SES Solar Two (08-AFC-5)

AFC Supplement in Response to CEC Data Adequacy Requests and

BLM Minimum Requirement Comments URS Project No. 27657106.00100

### **Supplemental Information** In Response to CEC Data Adequacy Requests and **BLM Minimum Requirement Comments Application for Certification (08-AFC-5)** SES Solar Two, LLC

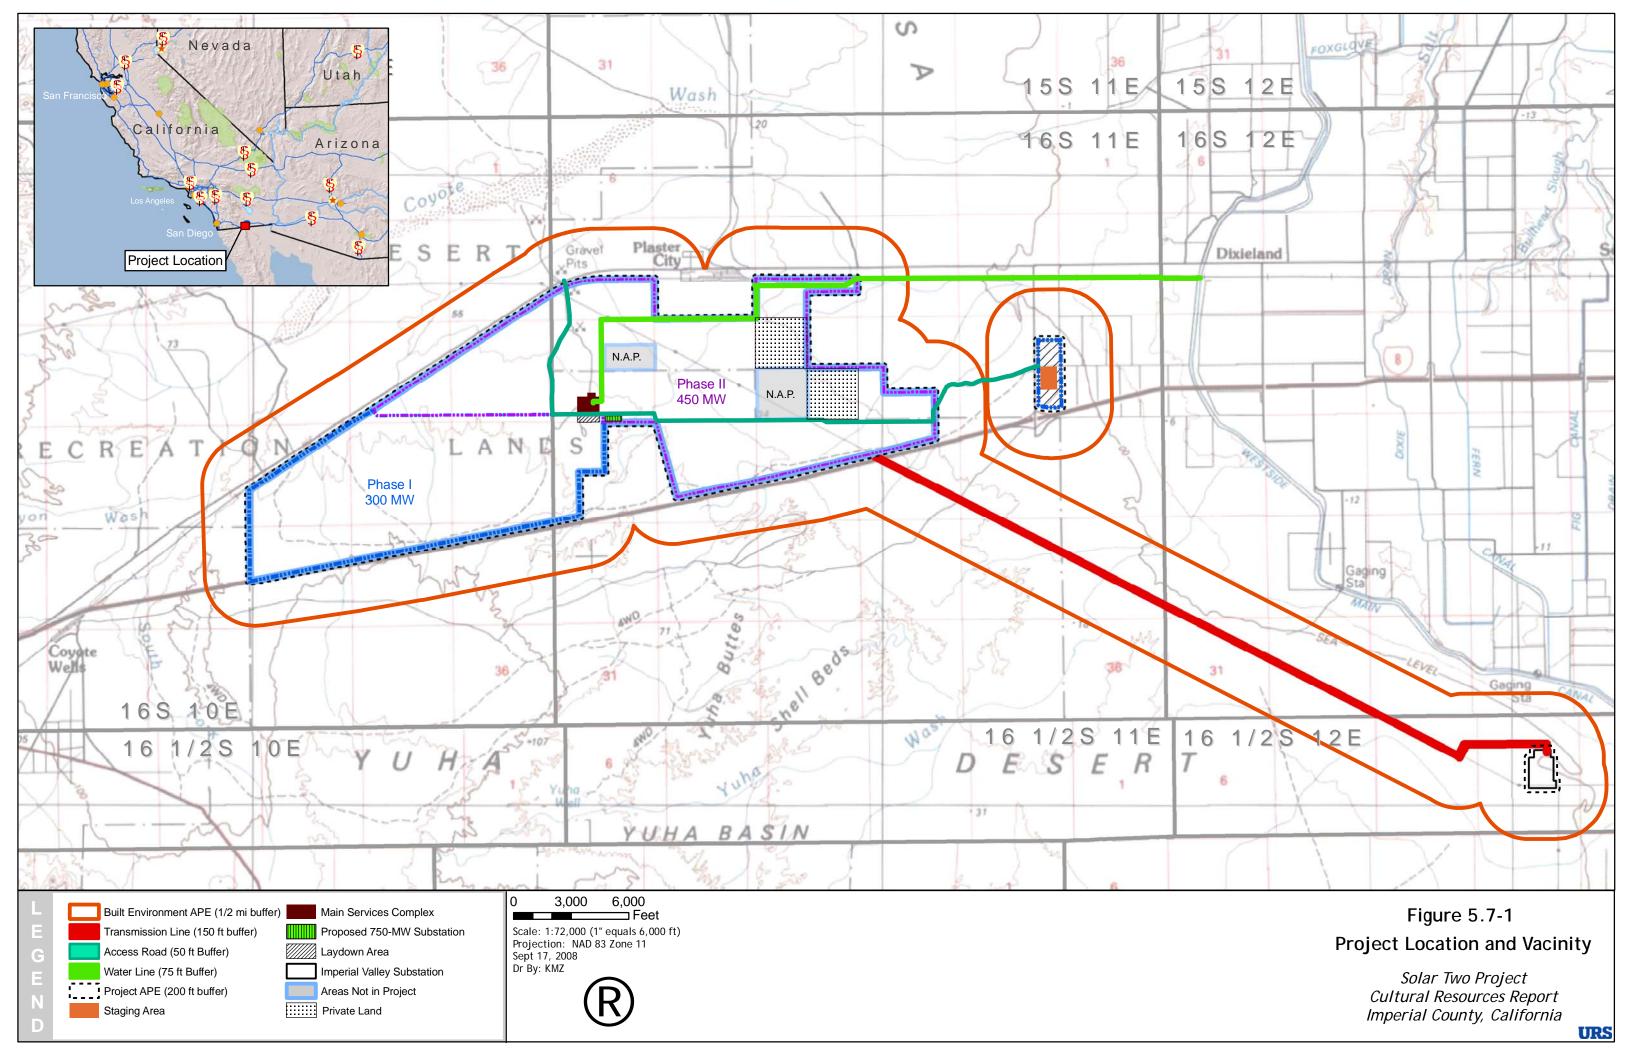
105	C Simmons	5.7	5.7-13	Figure 5.7- 1	Identifying numbers for survey projects on this map should correspond with a number on table 57-1. As it is, one cannot tell which survey area corresponds with which project title or author.	This comment has been addressed in the revised Cultural Resources Technical Report and revised AFC Section 5.7, Cultural Resources.		
	al Resrouces Inv	ventory Report -	General Con	nments	1			
106	C Simmons				By pushing forward with the timeline for submitting the AFC and not allowing enough advance time to submit a cultural report and get it finalized and approved by BLM (and the CEC), it is making it very difficult to comment substantively Many sections of the report are unfinished, missing completely or contradictory The sheer numbers of sites that were found and sensitivity of the area requires extra careful attention and proper documentation- this will only help the Section 106 and NEPA processes along in a timely manner in the long run.	This comment has been addressed in the revised Cultural Resources Technical Report and revised AFC Section 5.7, Cultural Resources.
